### STAFF RECOMMENDATION 1611 Fatherland Ave May 17, 2017

**Application:** New construction – outbuilding and Setback determination  
**District:** Lockeland Springs-East End Neighborhood Conservation Zoning Overlay  
**Council District:** 06  
**Map and Parcel Number:** 19514000500  
**Applicant:** Anna & Erwin Herceg  
**Project Lead:** Jenny Warren, [jenny.warren@nashville.gov](mailto:jenny.warren@nashville.gov)

**Description of Project:** Construction of a new outbuilding with a side setback determination.

Standing seam  
wooden eaves

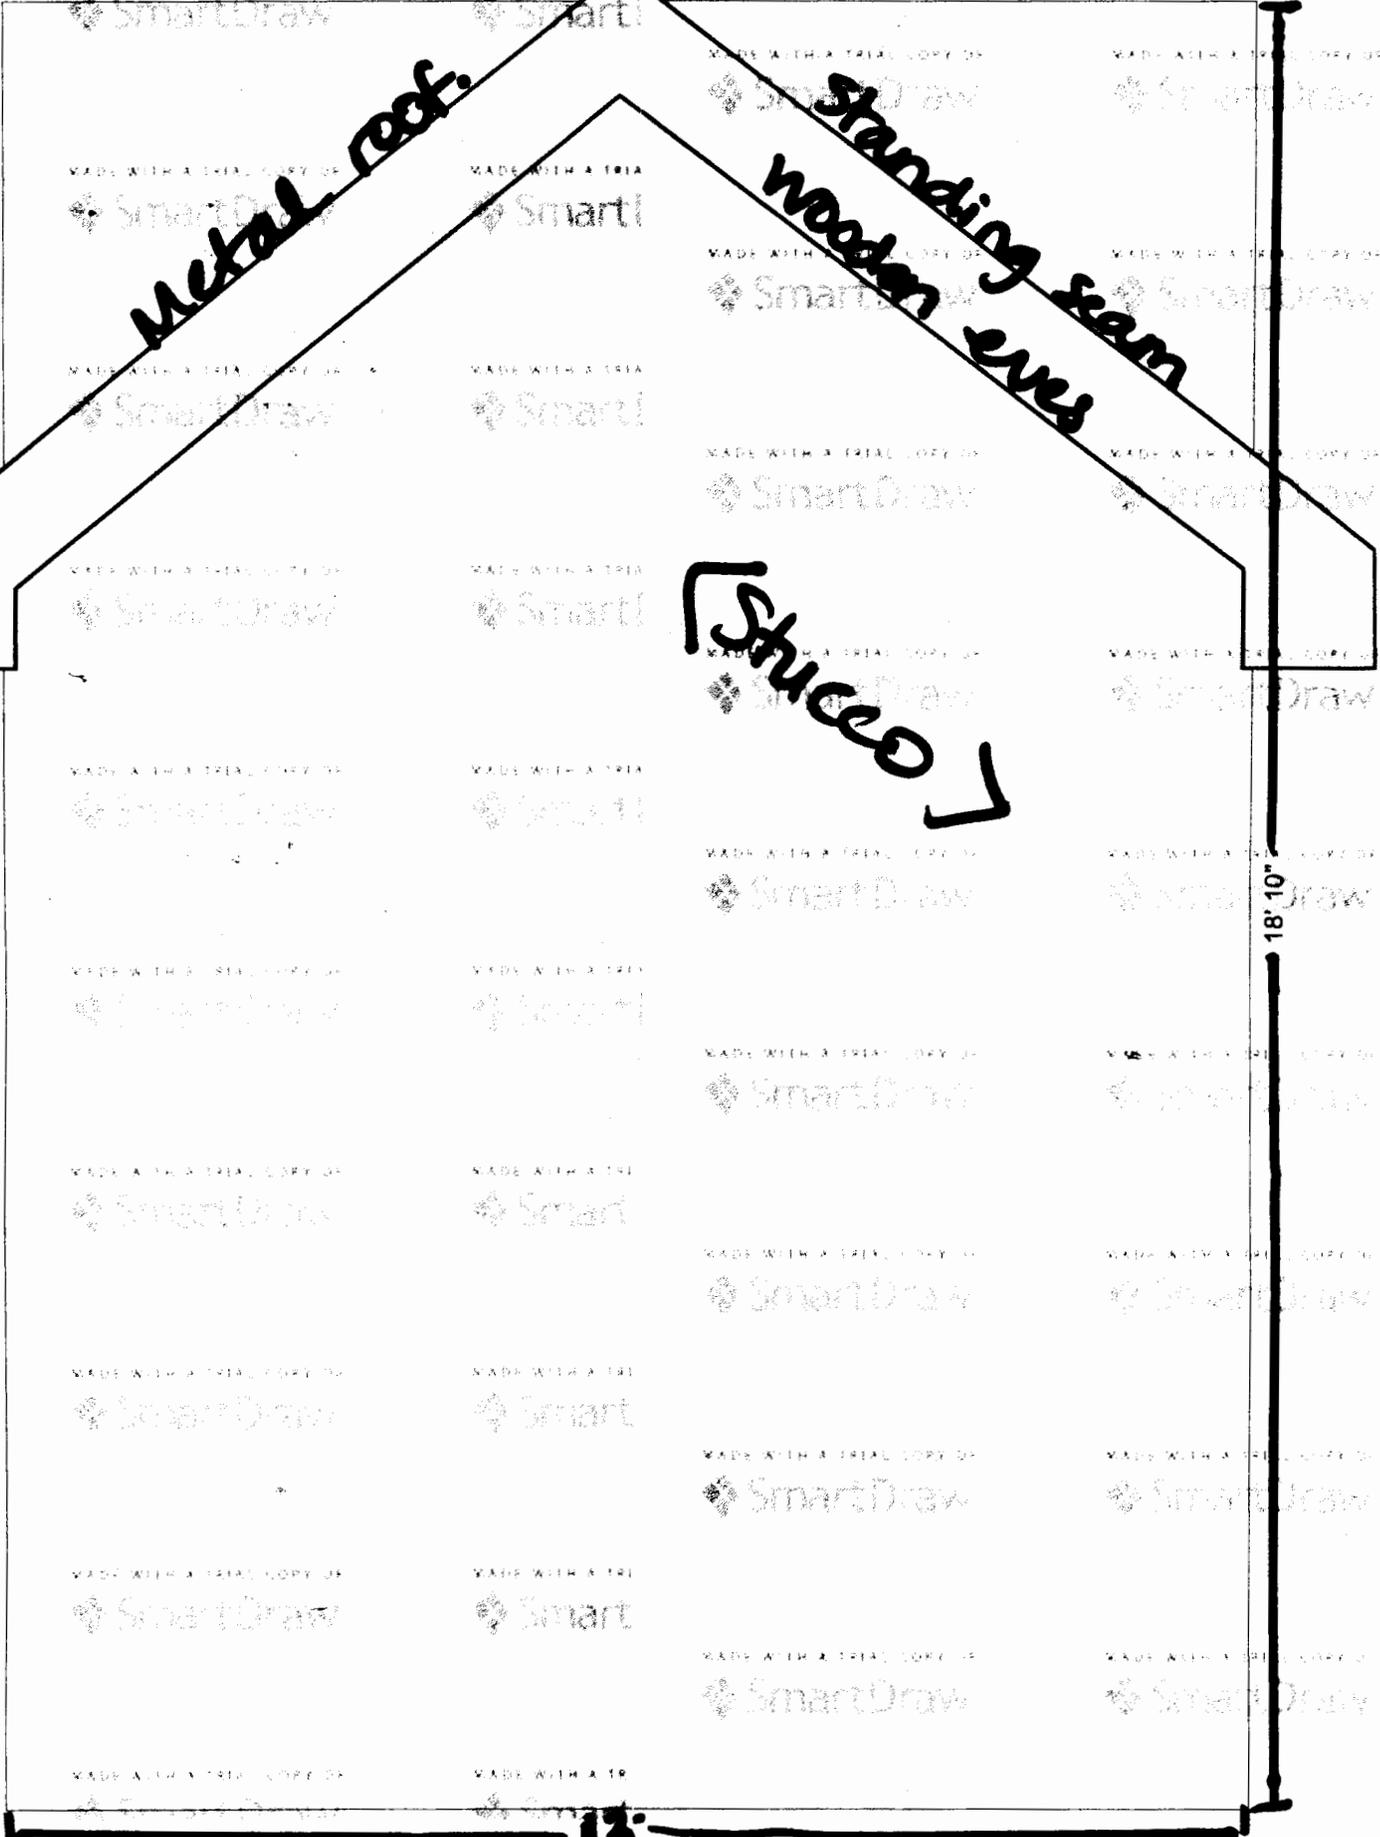
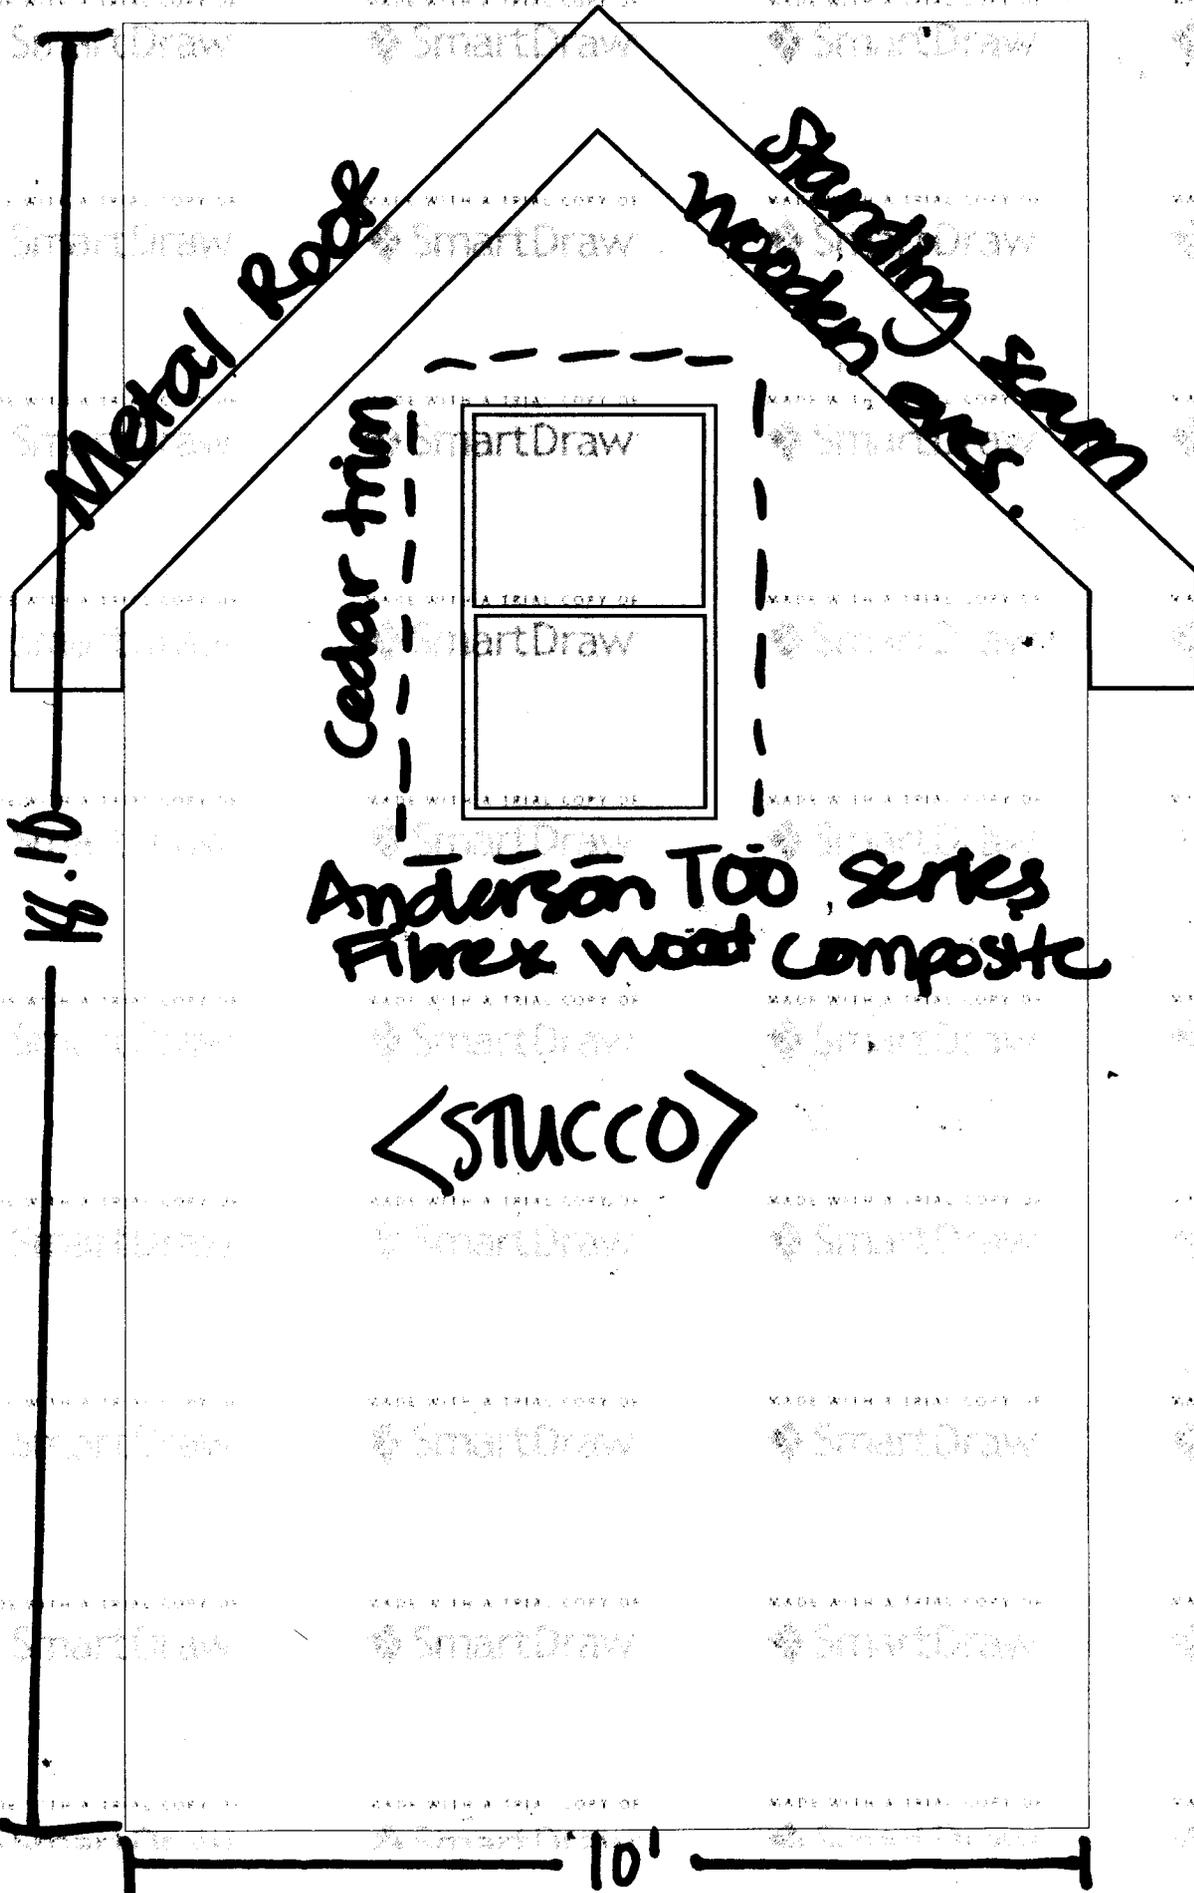
With staff's final approval of the stucco finish, staff finds that the known materials meet Section II.B.8 of the design guidelines.

Ridge height is 18.5' compared to 28' of the principal structure.  
Eave height is 12' compared to 21' on the principal structure.  
Cladding is stucco  
Windows and doors have 4" wood trim.  
Windows: Anderson 100 series,  
Fibrex wood composite  
Door:  
Roof: Standing seam metal to match principal house

1. Staff approve the stucco color and texture.
